ADDENDUM #1 – Q&A

Tower Elevator Cabs Refurbishment

ITB 89-0160

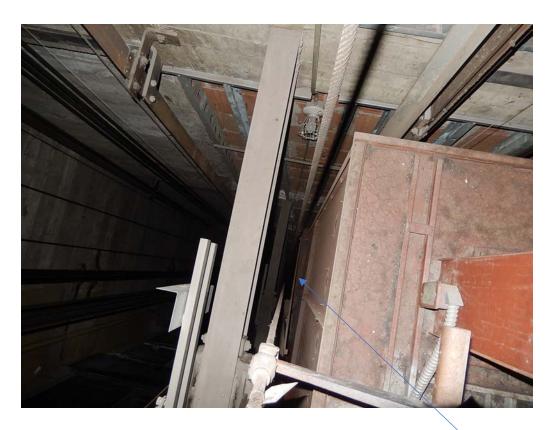
Q5: At the bid walk, having you provide photos of the cab from the hoistway - when will they be available?

The offset occurs between here and here

There is no apparent reason for the offset as the platform is in the typical rectangle shape of the cab and does not have an offset or notch.

The platform can be seen in its typical rectangular shape here.

A5: See Attached – Next Page
